**MEETING AGENDA
SESSION OF THE HISTORIC PRESERVATION BOARD
CITY OF KISSIMMEE
CITY HALL, COMMISSION CHAMBERS
101 CHURCH STREET, KISSIMMEE, FLORIDA 34741-5054
MONDAY, JANUARY 8, 2024 AT 5:15 PM**

509 Verona Street

New 72-square foot machine room at 509 Verona Street.

FRONT ELEVATION
SCALE: 1/4" = 1'-0"

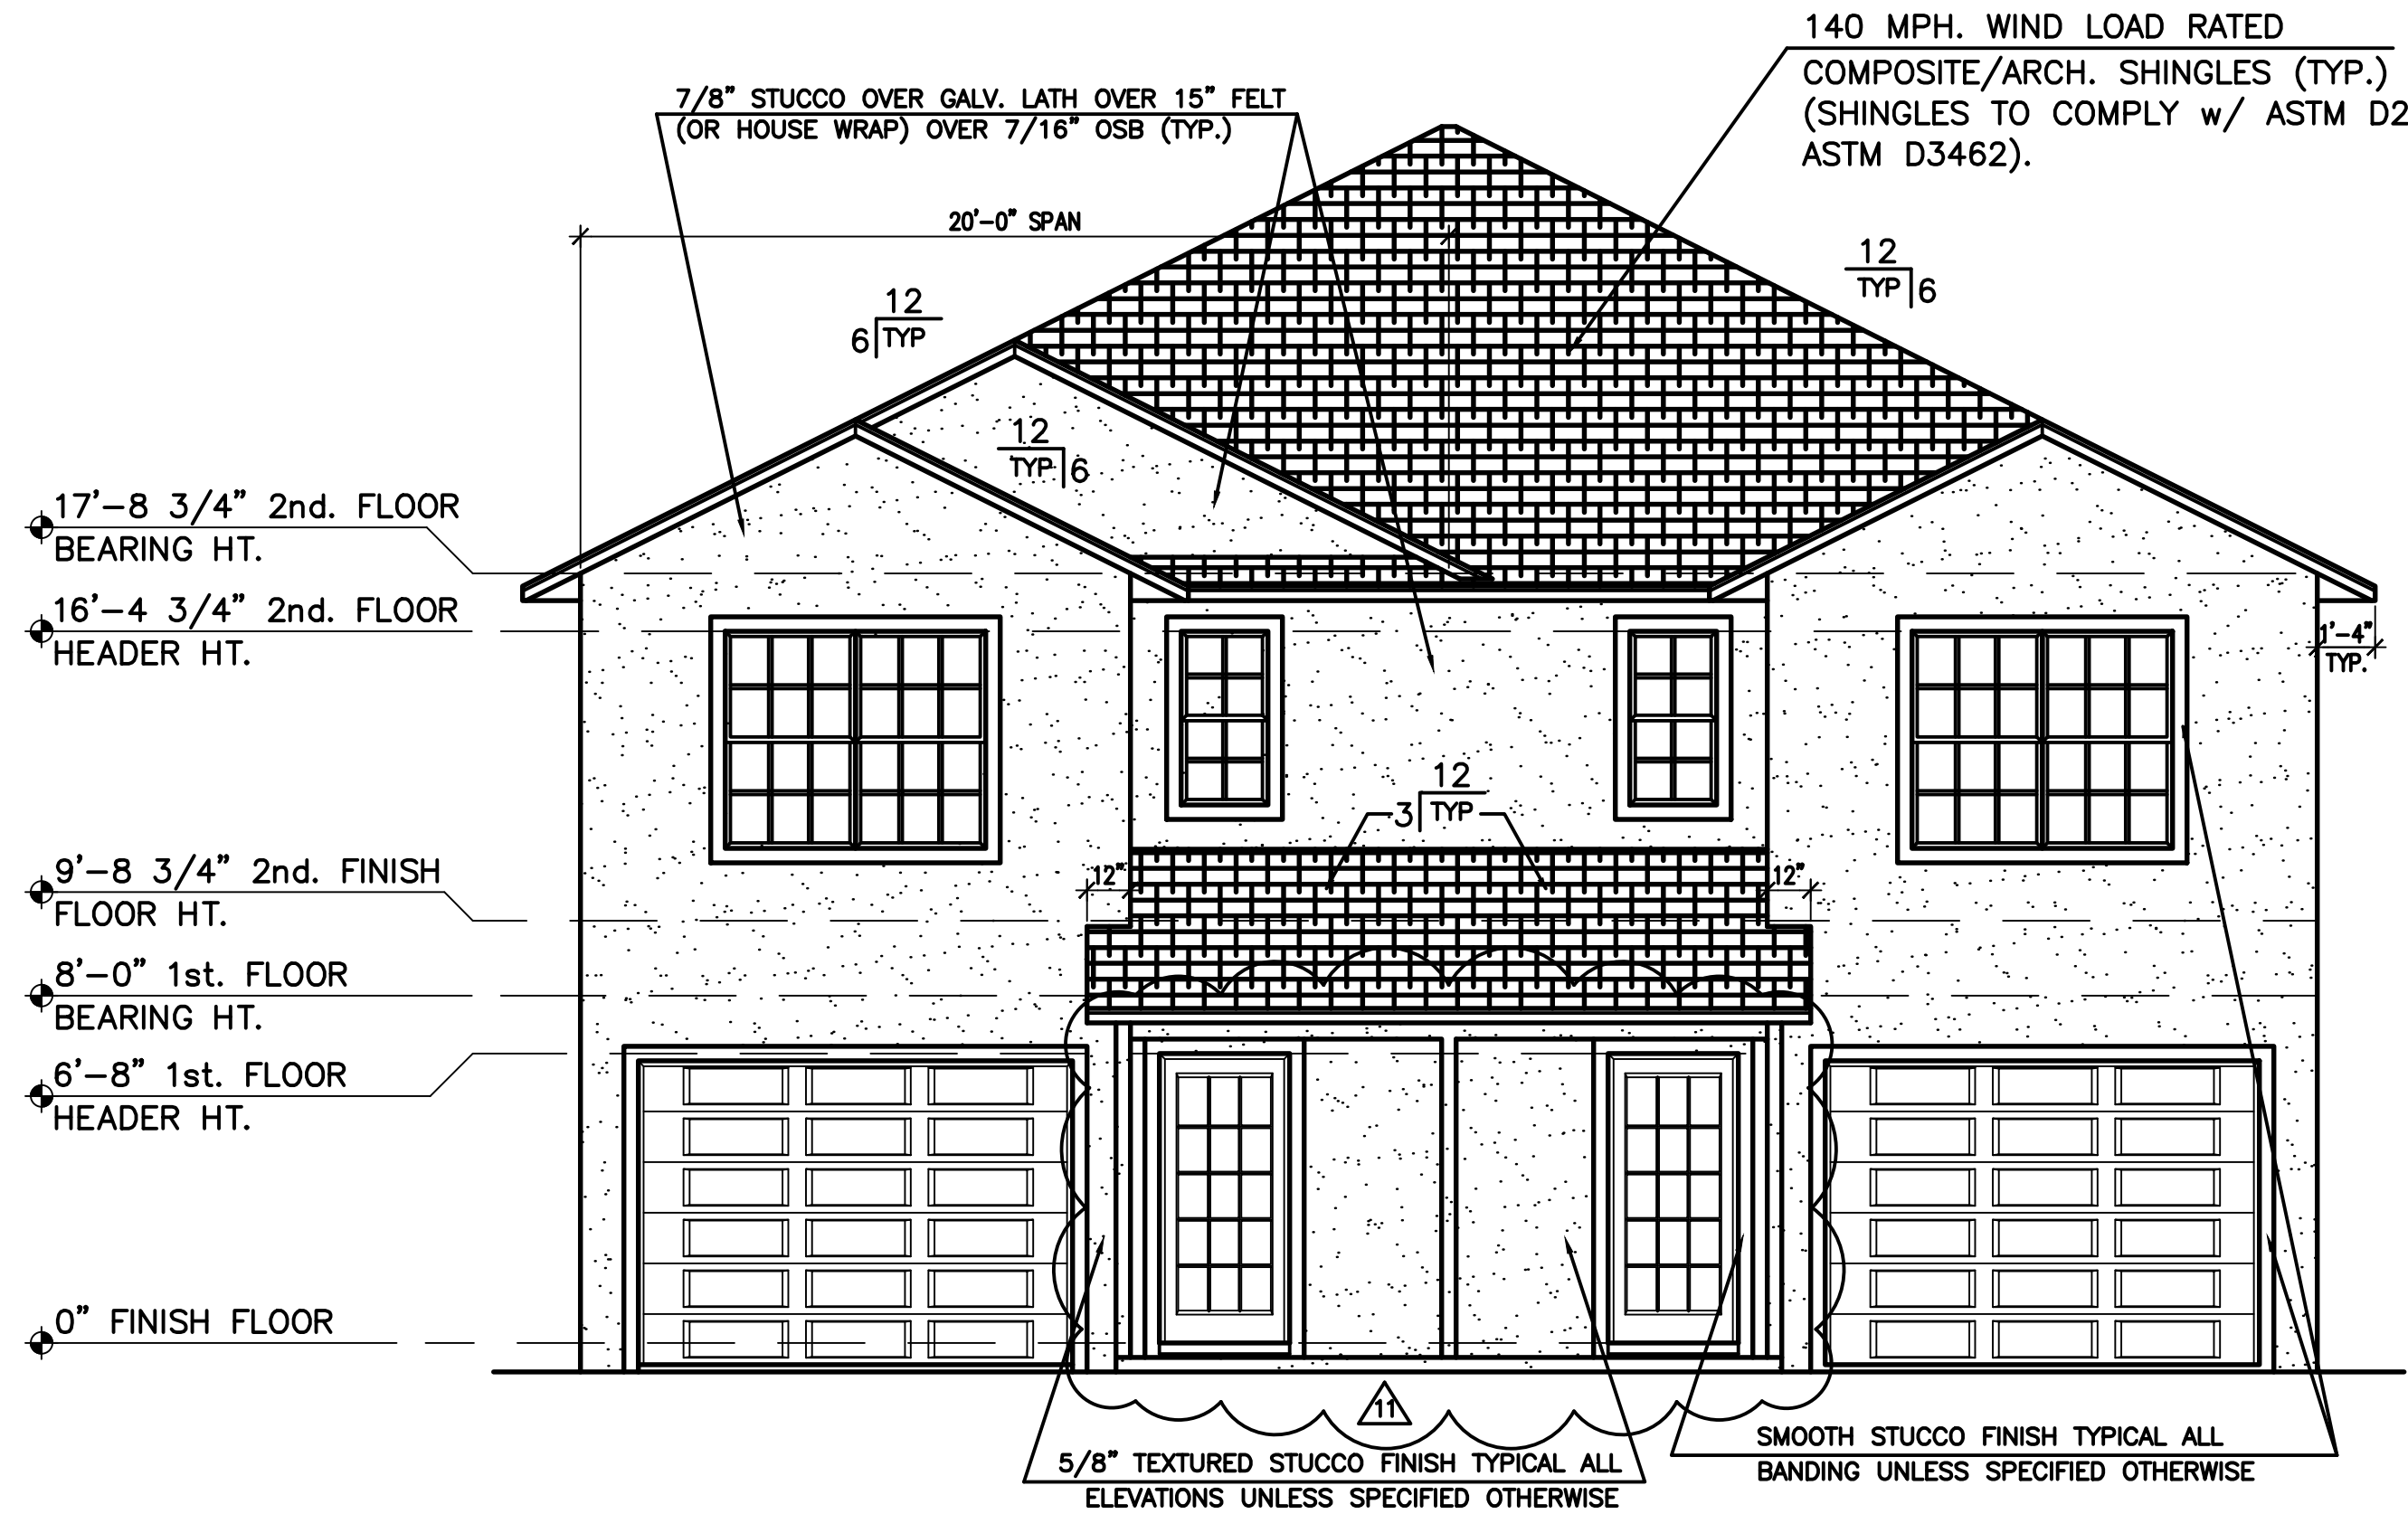
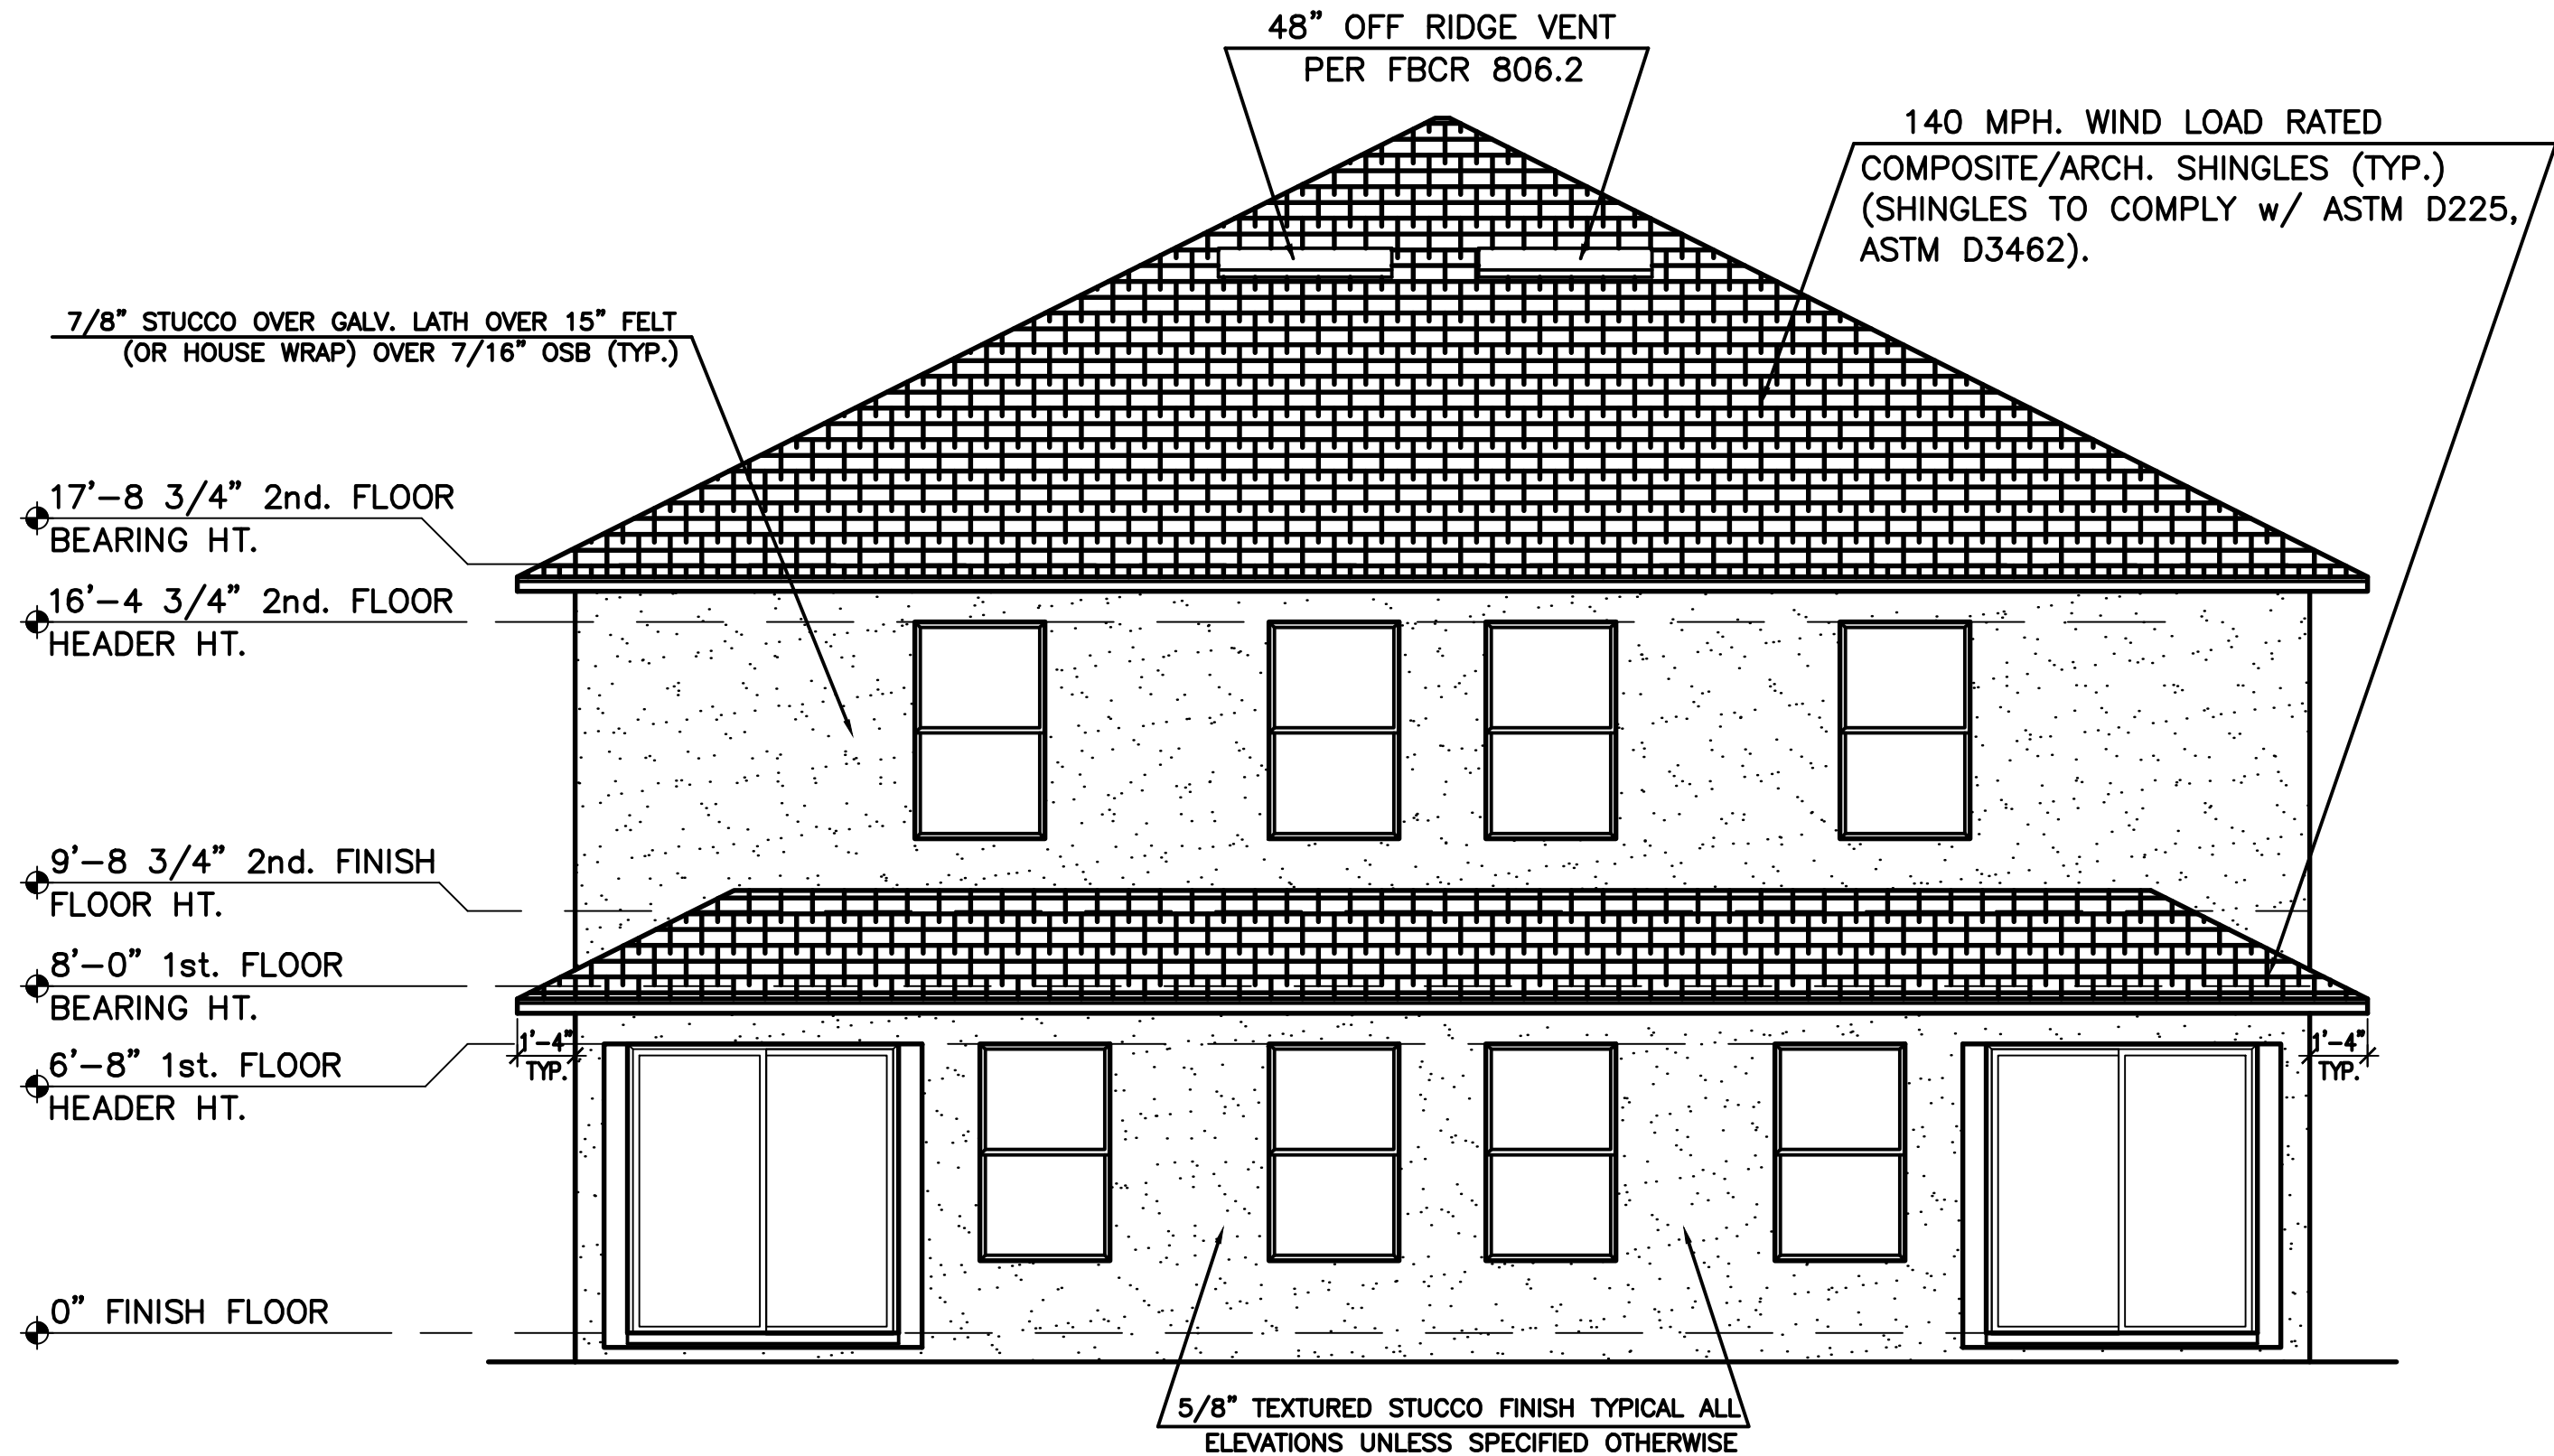
Since this property is on the edge of the South Beaumont district, and the only parcel fronting on Harford within the district, staff did not hold issue with a more modern design for the front of the structure. However, the proposed building is two stories and will be approximately 40-feet from the back of single-story structure at 725 Mabbette and the back and rear elevations will be seen from Mabbette. Due to this, staff is recommending that the applicant add architectural features to those elevations (sides and rear) to provide relief to the almost blank walls currently proposed. It is recommended to add additional windows and use some of the features from surrounding structures (e.g. a wide banding around the windows, a different window style, shutters, even window placement, and/or varying roof levels on the back). This will help make the transition between new and historic less awkward while respecting this property's location and proximity to newer construction.

Approval with the conditions that additional features be added to provide a smoother transition to the historic structures to the south.
